REF: CHEMPRO-PIER 91, DRAFT WORK PLAN

REF: Review of Draft Work Plan, Chespro Pier 91,
September 4, 1990

FIGURE 1

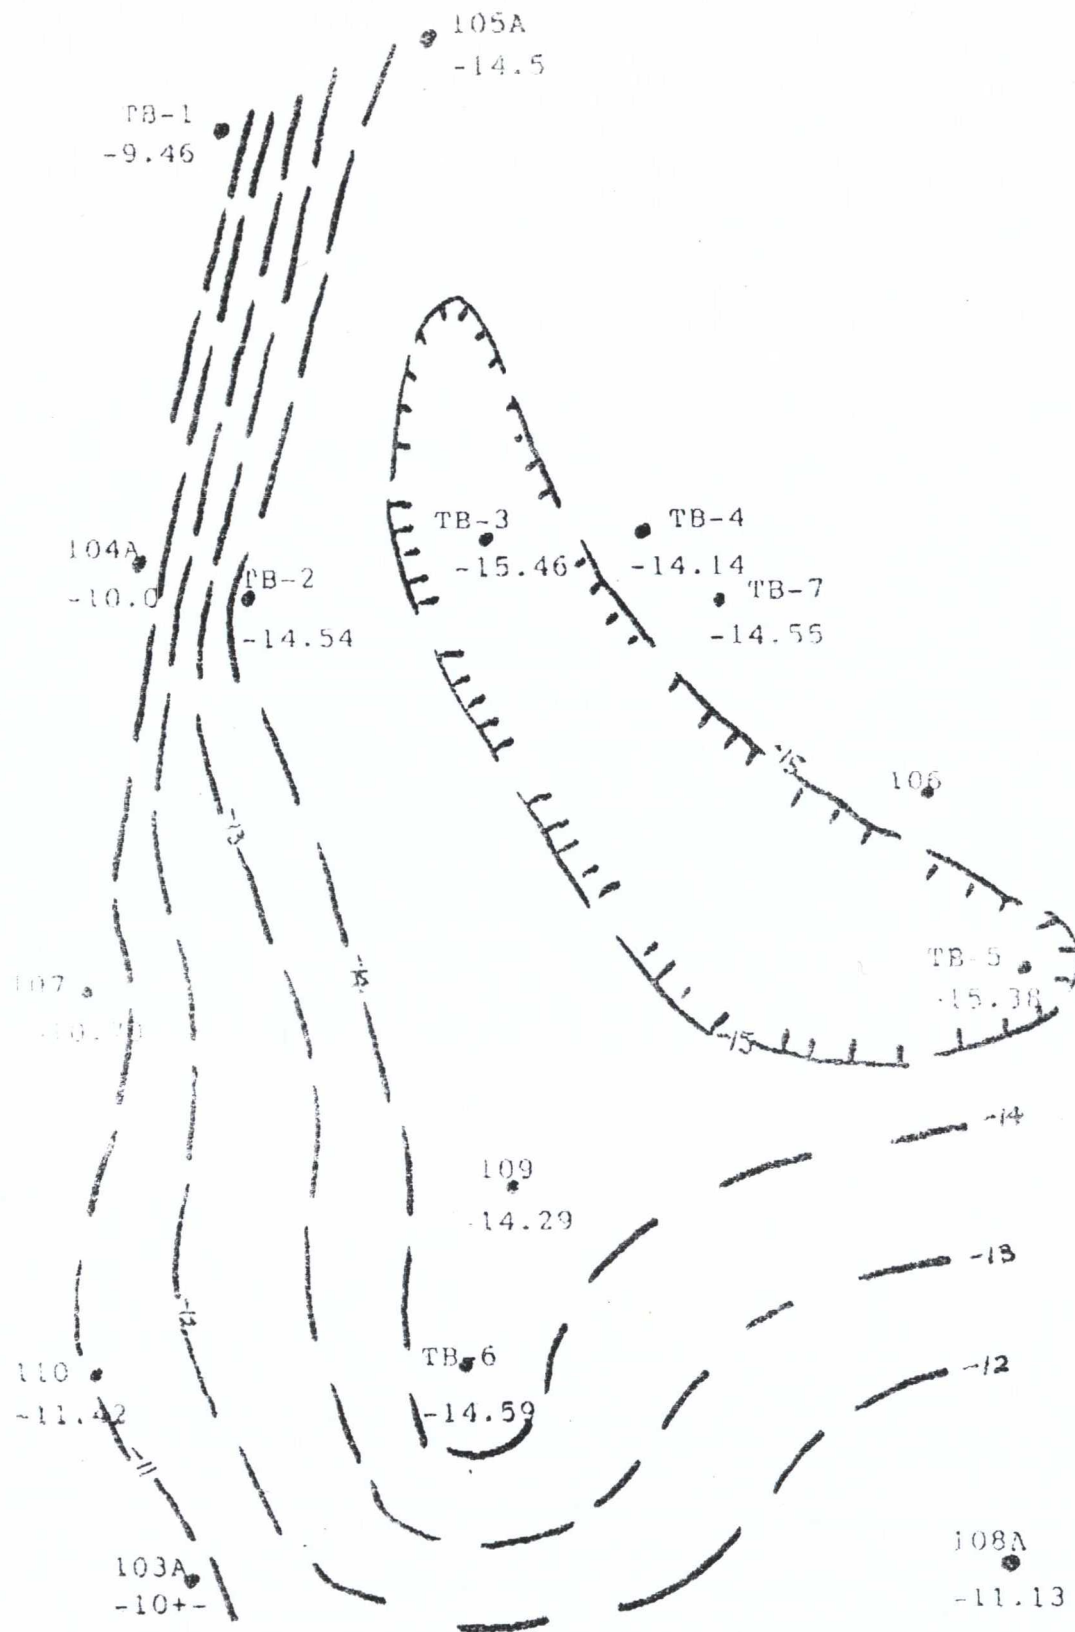
This aquitard is of critical importance in understanding the ground water flow at this site. If it is a legitimate barrier to ground water flow vertically, then it should prevent vertical migration of contaminants and should result in a considerable cost savings in the volume of ground water that has to be cleaned up. At a minimum a contour map of the upper surface of the aquitard should have been prepared. This surface has the potential to control the spread of DNAPLs, change the ground water velocity as the upper aquifer thins and thickens, and change the direction of ground water flow. Attached figure 1 is a contour map of the upper surface of the silty sand layer. The most important feature is a four to 5 foot drop in the surface that runs north/south down the west side of the facility. The change in elevation of the bottom of the upper aquifer from +15 to -10 feet should have a significant impact on the velocity of ground water on either side of the escarpment.

FIGURE 2

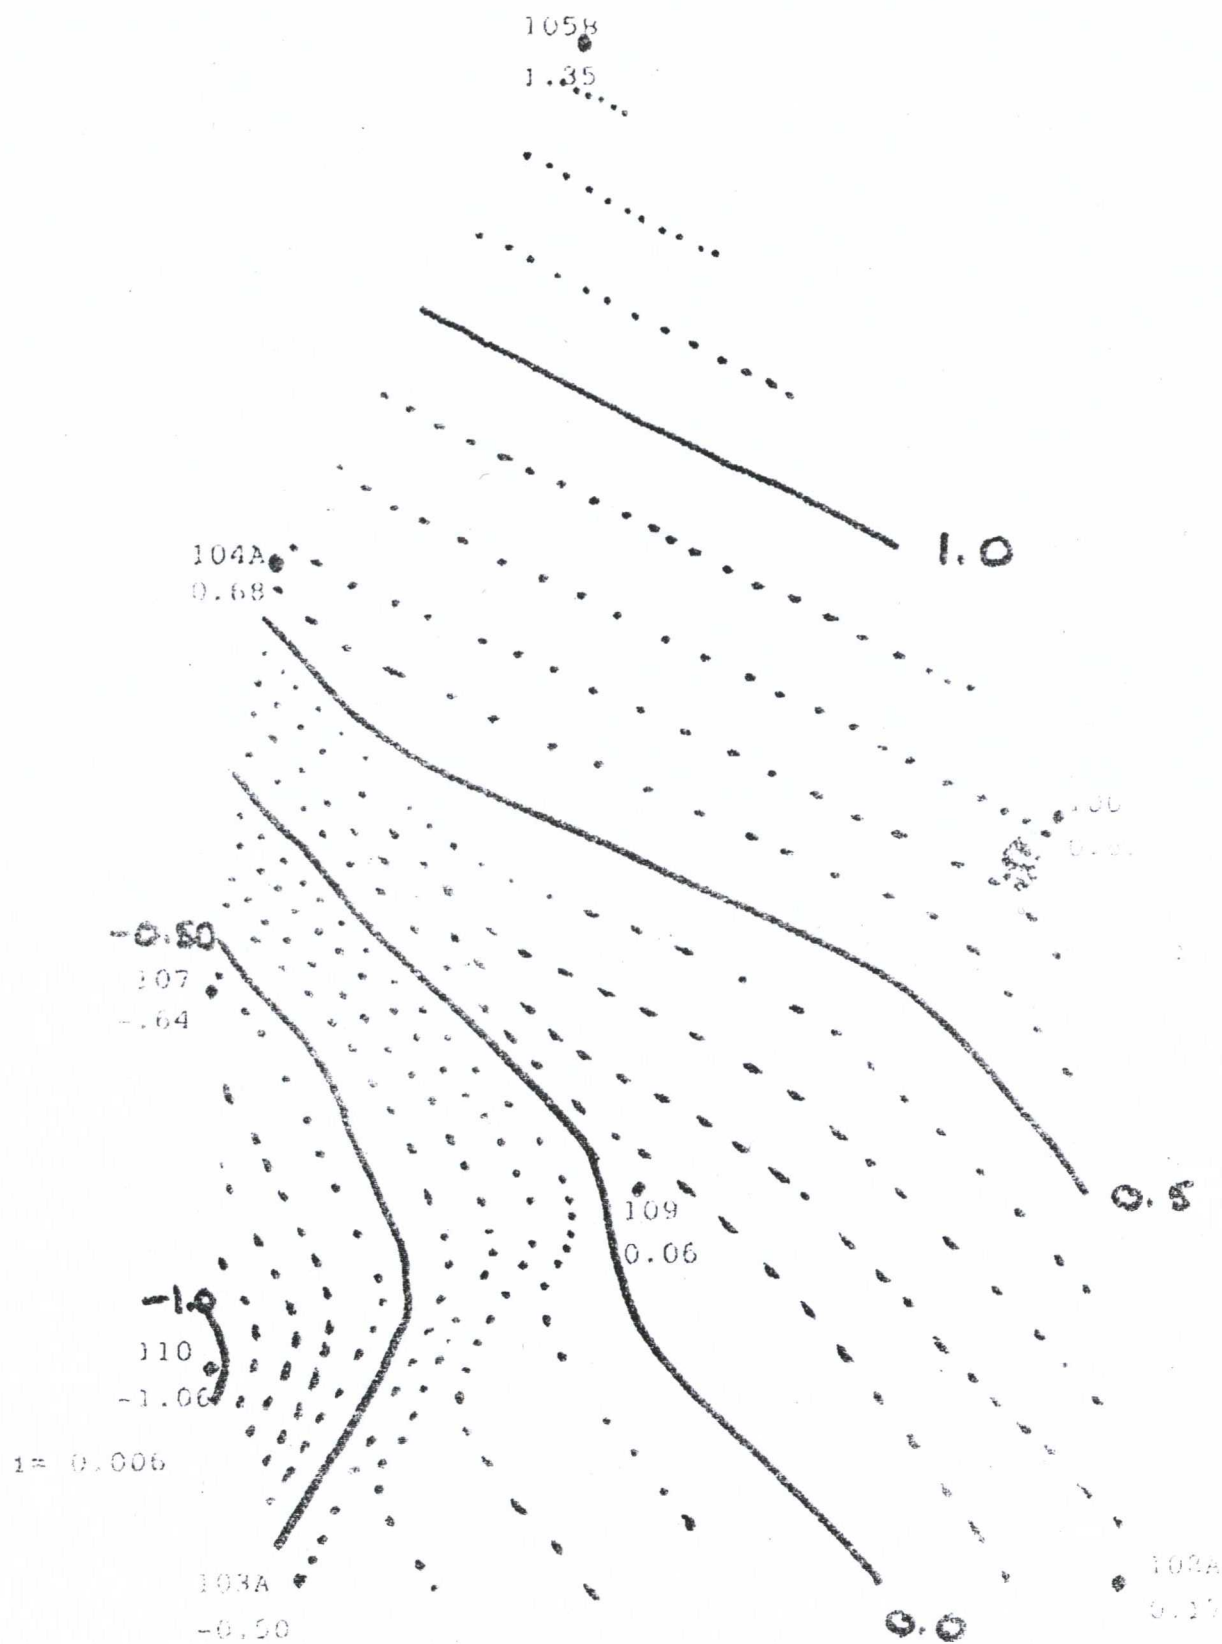
Attached figure 2 is a contour map of the head data for the shallow aquifer. There is a doubling of head between wells 106 and 109 and wells 109 and 107 as would be expected if the thickness of the aquifer is decreased by half. To move the same volume of water requires the doubling of the ground water velocity. Since D , K , and n are constants, the area becomes smaller, only i can increase.
